From: Rael, Rudy E.
Sent: Wednesday, September 28, 2016 11:21 AM
To: 'bwarren@bhinc.com'
Subject: Highland High School

Based upon the information provided in your resubmittal received 9/1/16, the above referenced Grading and Drainage Report and plan cannot be approved for Grading Permit or Building Permit until the following comments are addressed:

ALBUQUERQUE PUBLIC SCHOOLS HIGHLAND HIGH SCHOOL TITLE IX GYMNASIUM UPGRADE

A1 DRAINAGE MANAGEMENT PLAN
SCALE: 1" = 30'

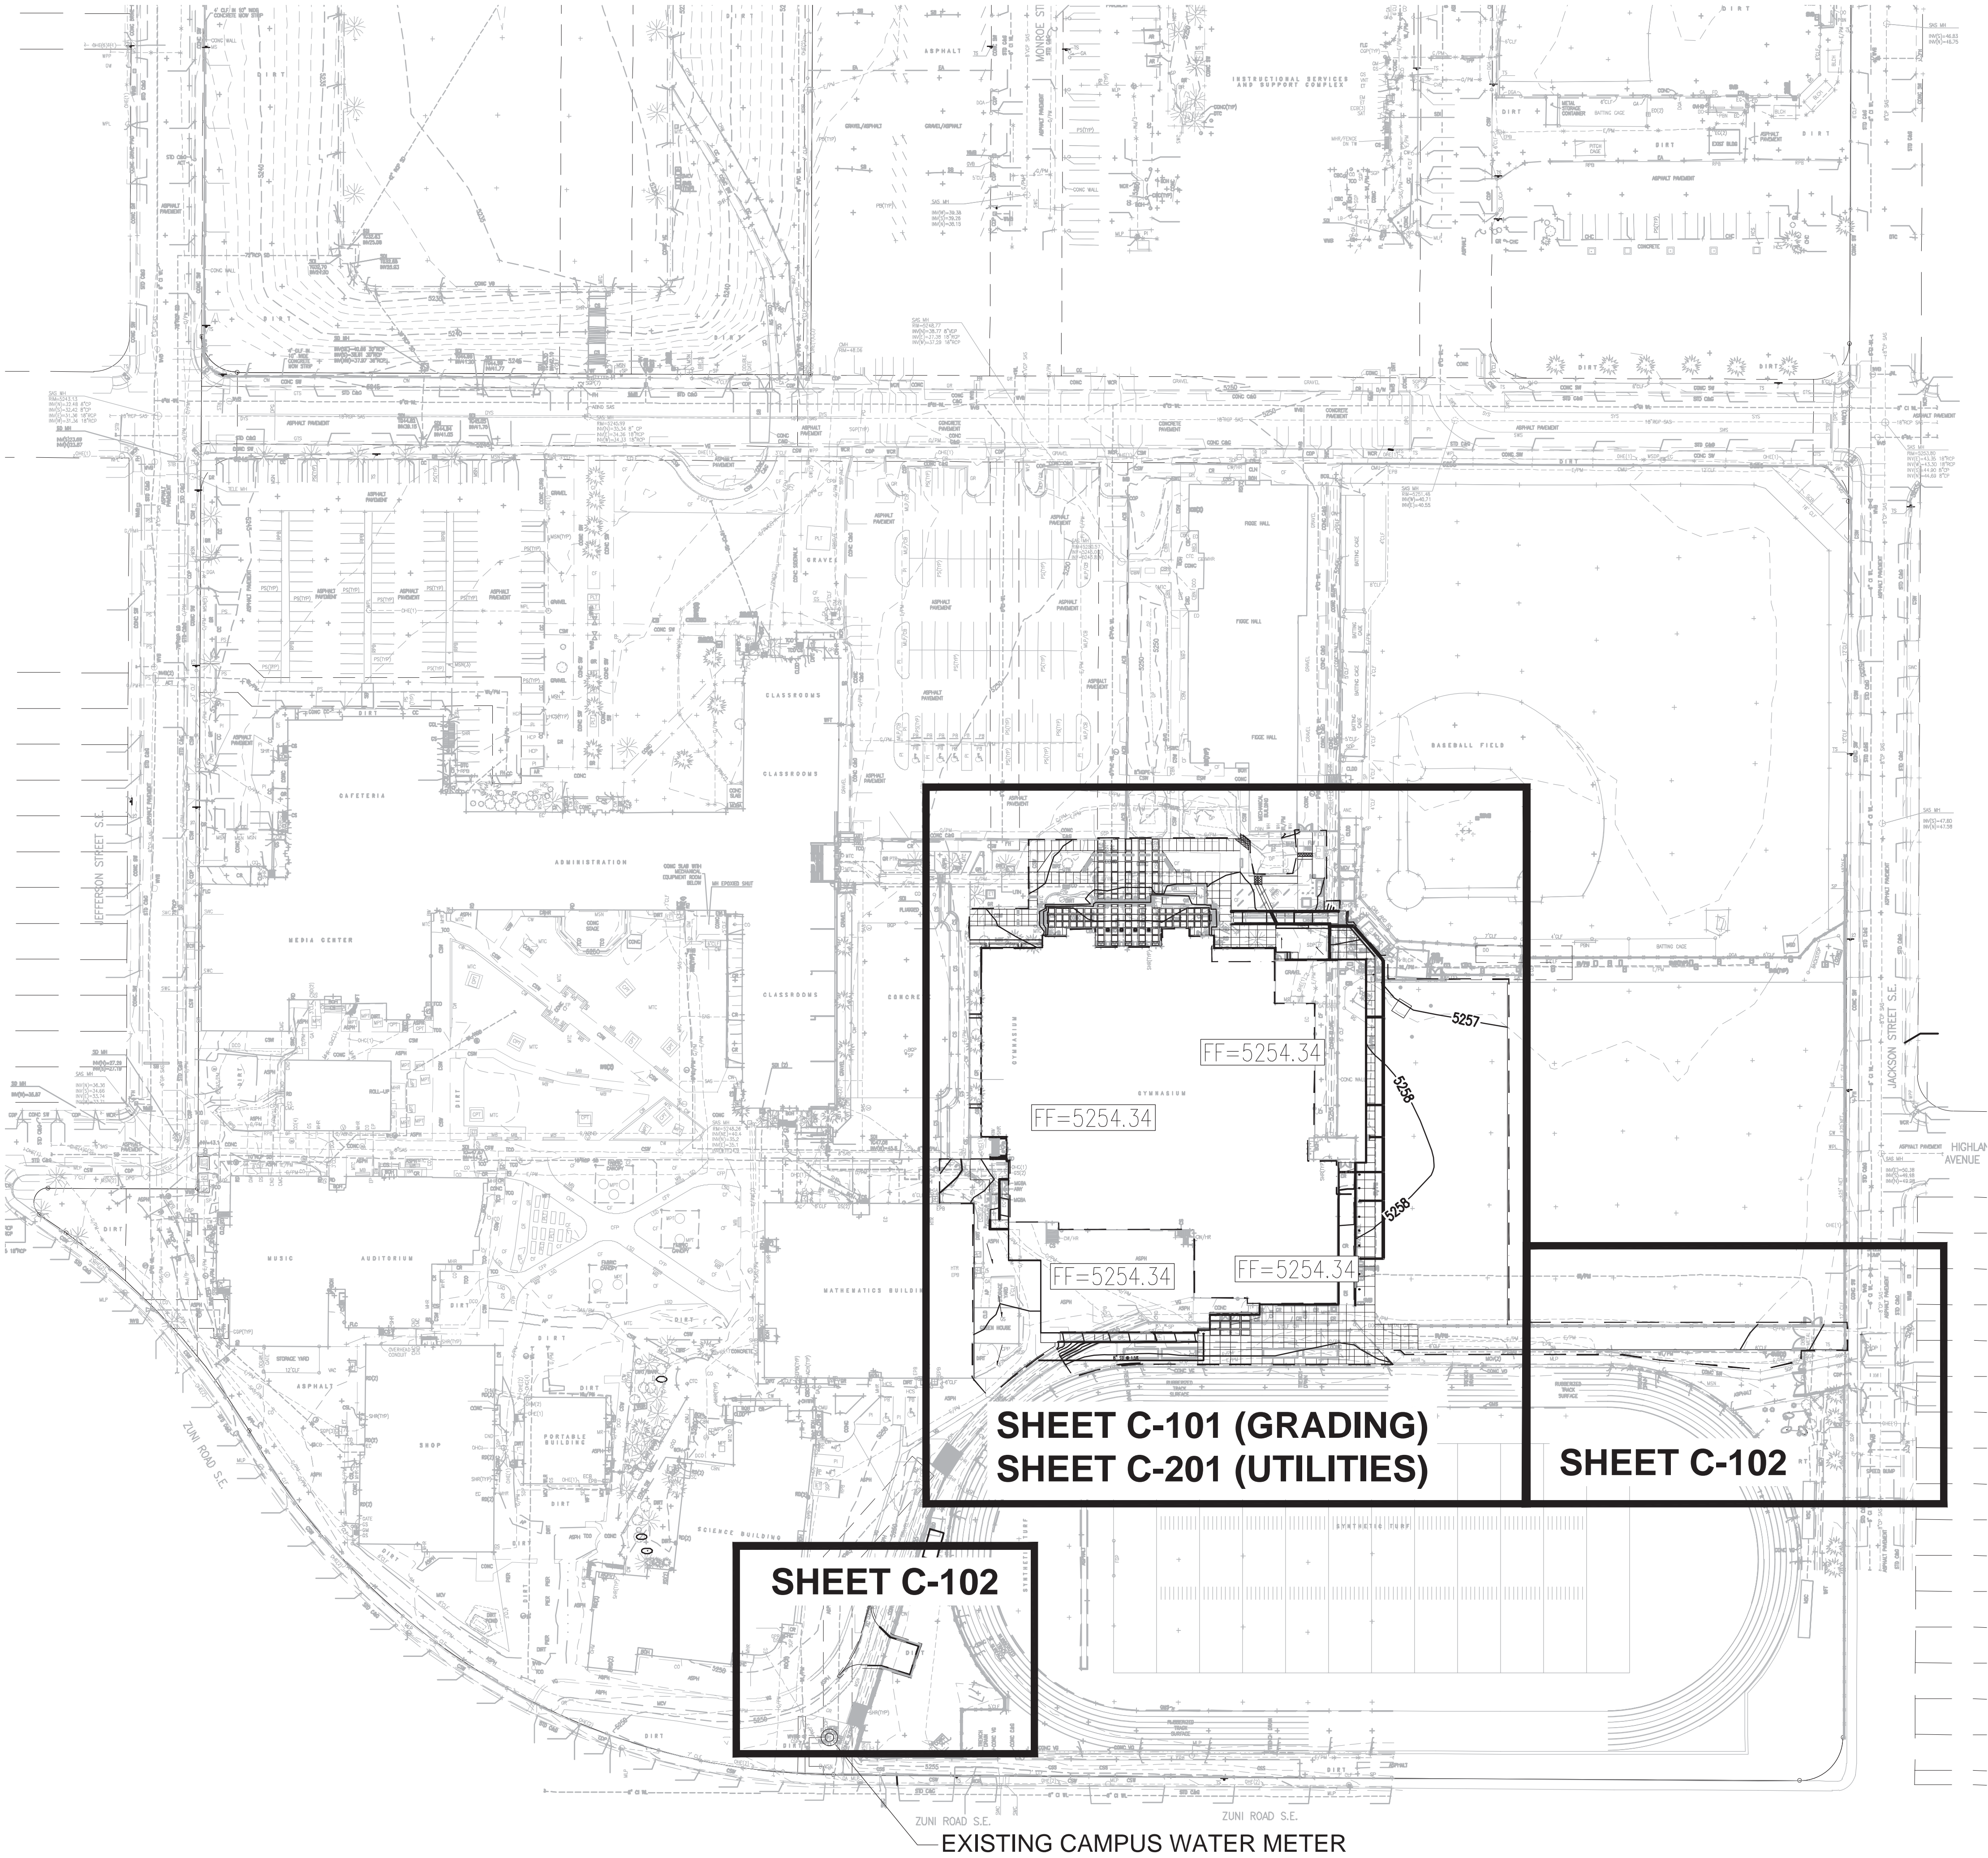
- The plans are too cluttered, provide a separate Demo plan showing what is to remain and what is being demolished.
- Provide a detail for the retaining walls. Separate permit is required for the walls.
- Provide roof flows. Where are the flows headed in the NE addition? Is there a water harvest pond for this new area?
- Connect the new drive with the old drive per Master plan dated 9/2/2015 provided by High Mesa Consulting Group.
Consult with Transportation.
